Mahopac Central School District  
Mahopac, New York

Reconstruction at  
Mahopac High School  
Mahopac Middle School  
Mahopac Falls School  
Bus Garage  
New Pump House

BID Addendum No. 4  
to  
Drawings and Project Manual

March 1, 2021

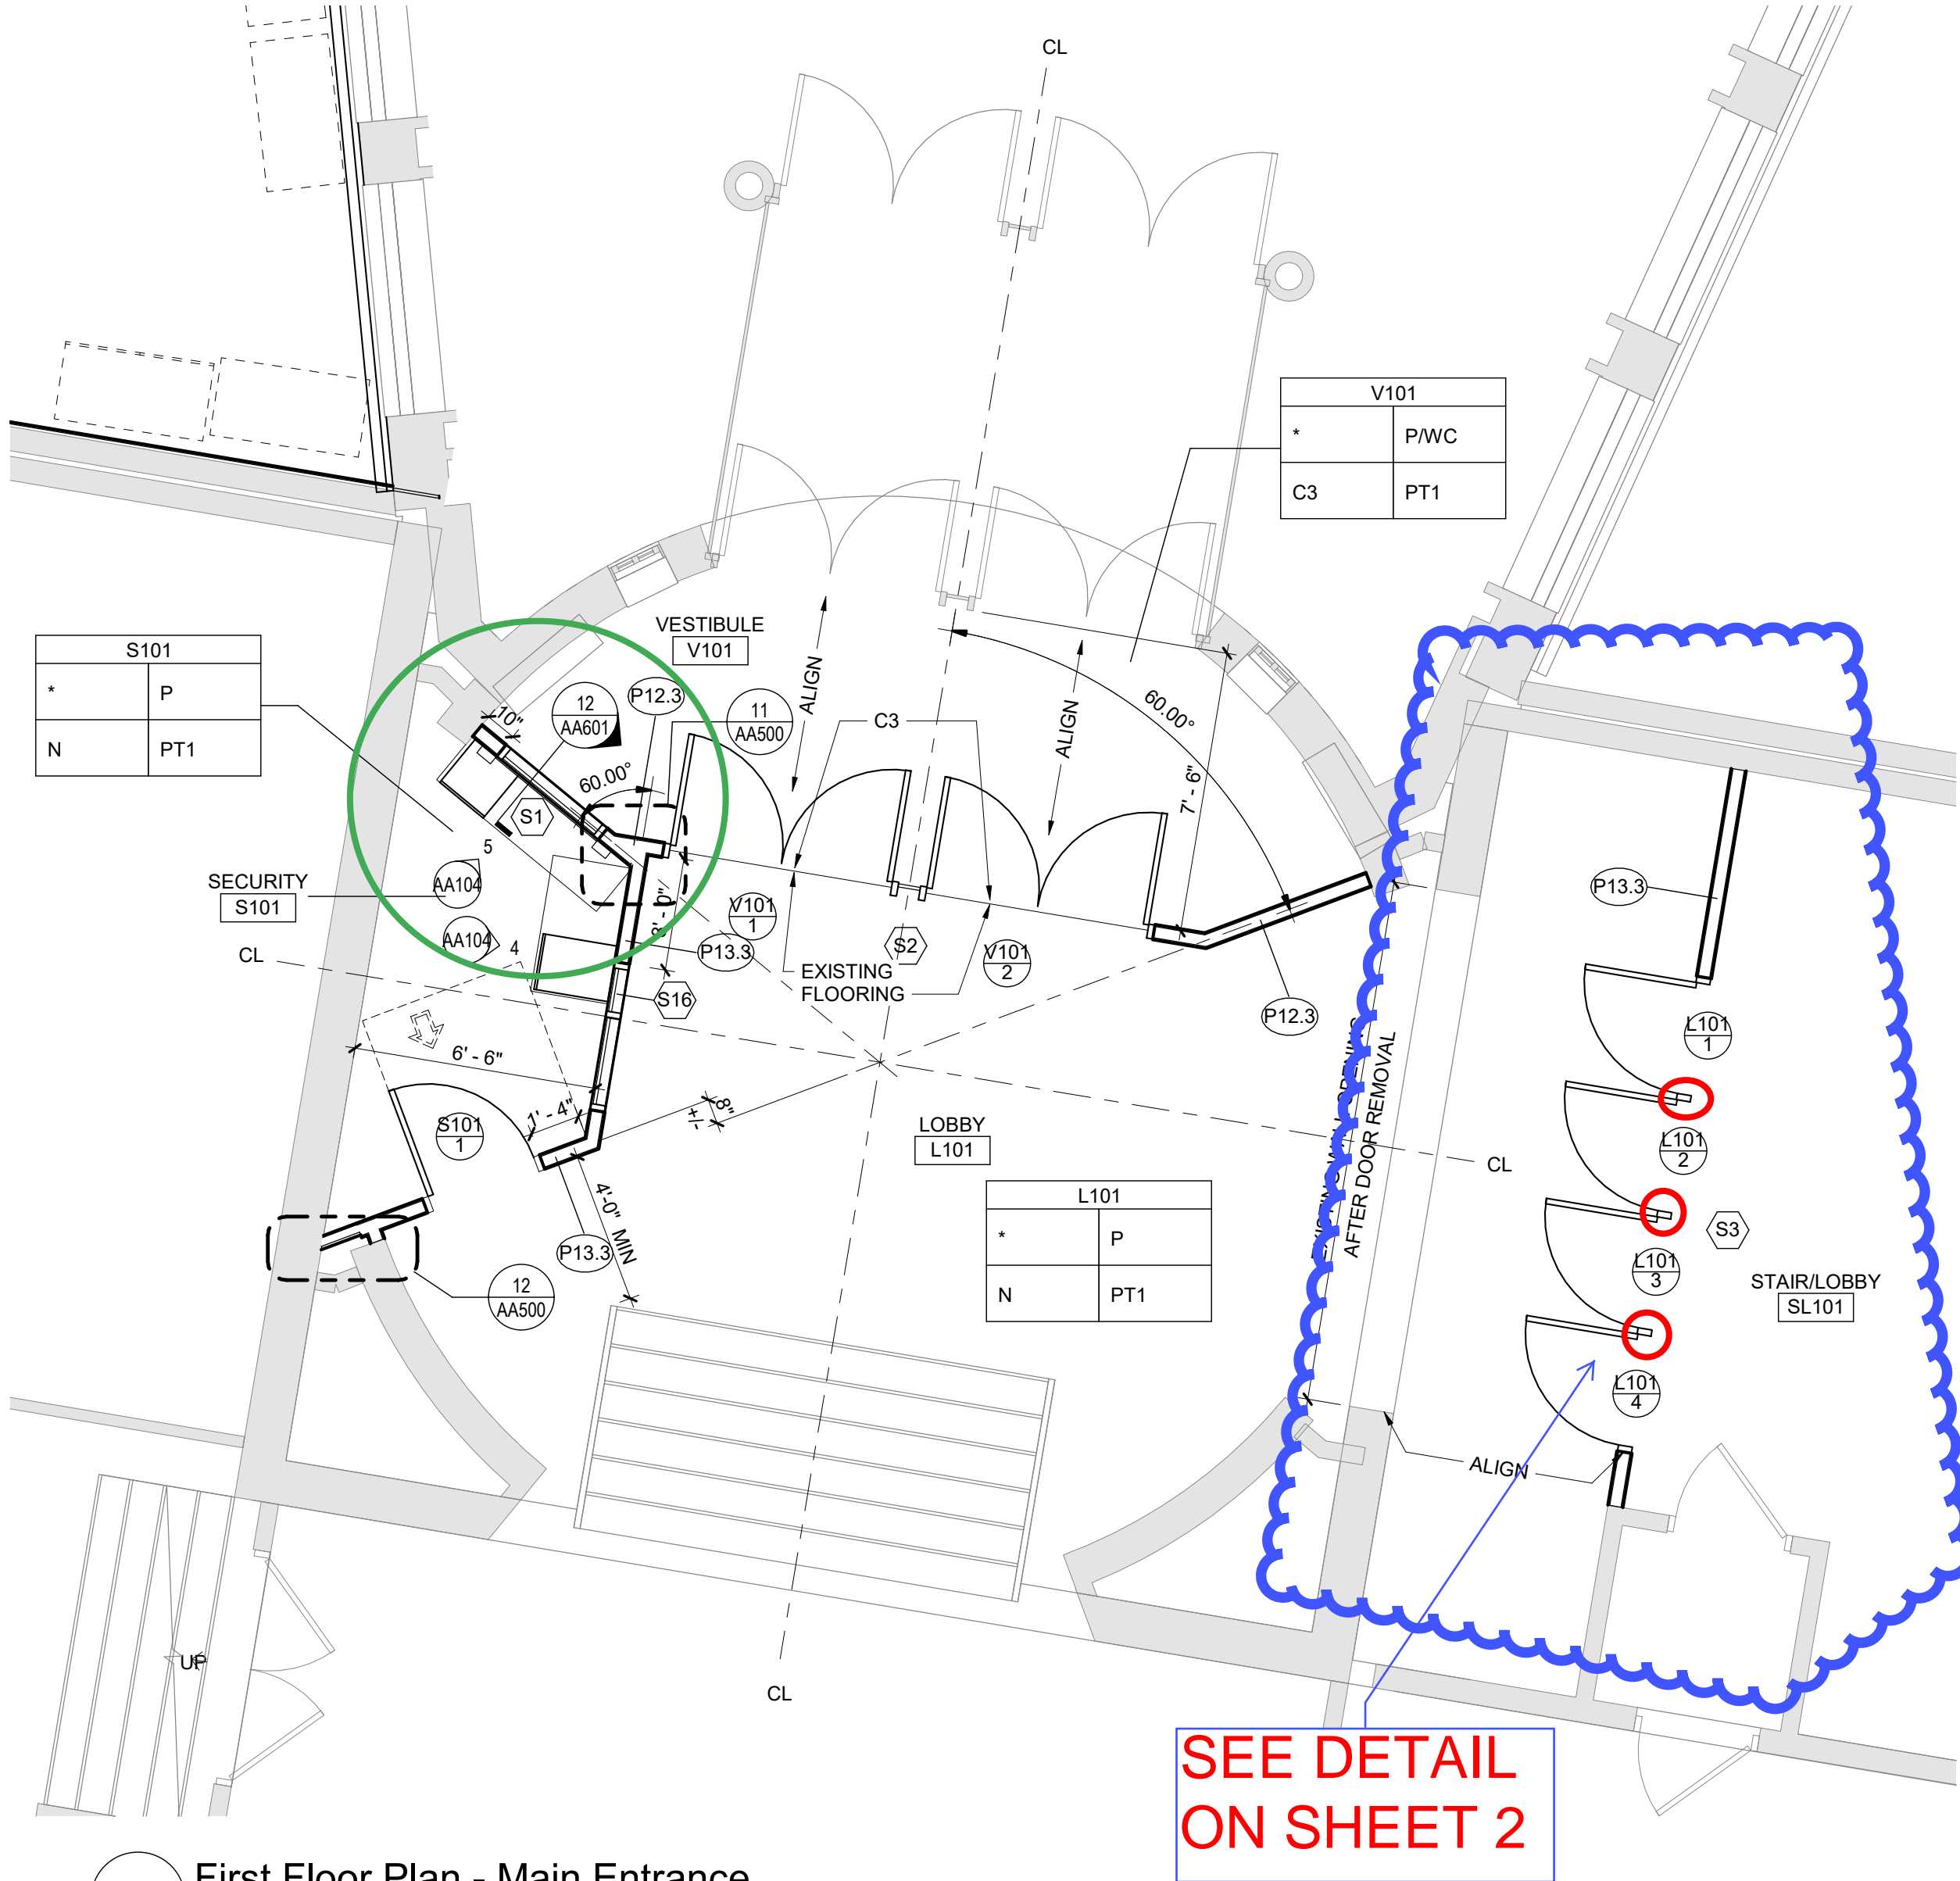
We would need to use the same full height glass Designer doors as we are using in the other elevations. Also and most important, we need to divide these into 4 separate single door/frame units. These would be separated with either a small section of "wall", or perhaps a steel tube. The steel and any structural calcs if needed would be By Others.

Drawn By: TS	Date: 8/21/20	Drawing Number: <b>AA104</b>
Project No.: 121111-19002

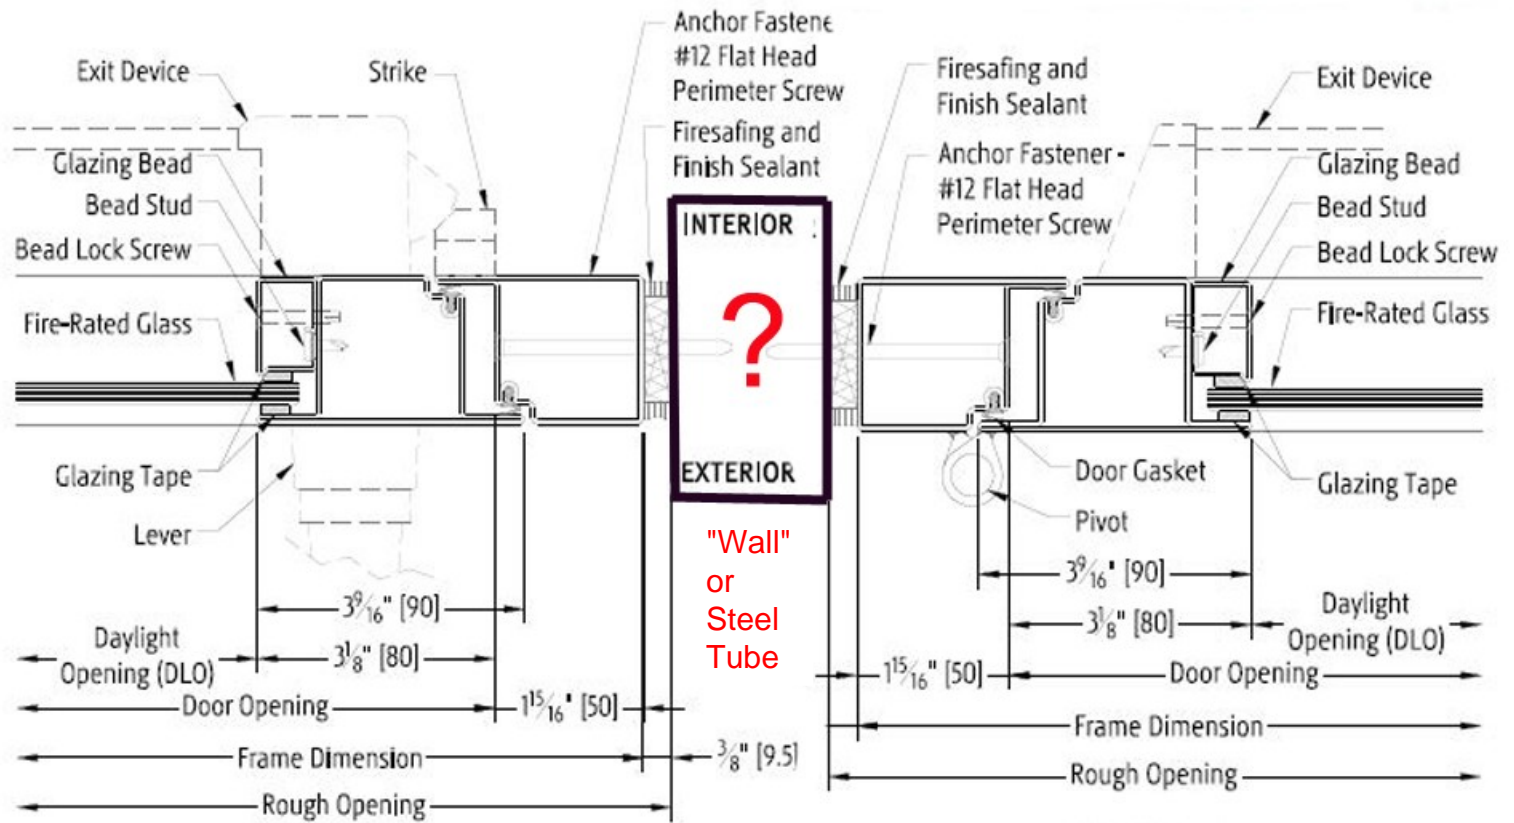
- 1. Doors L101-2, L101-2, L101-3 & L101-4, AMEND the plan to show 4" portions of Wall Type P13.3 between each of the doors in order to create 4 separate aluminum frame door openings instead of these 4 doors being contained within one frame unit.
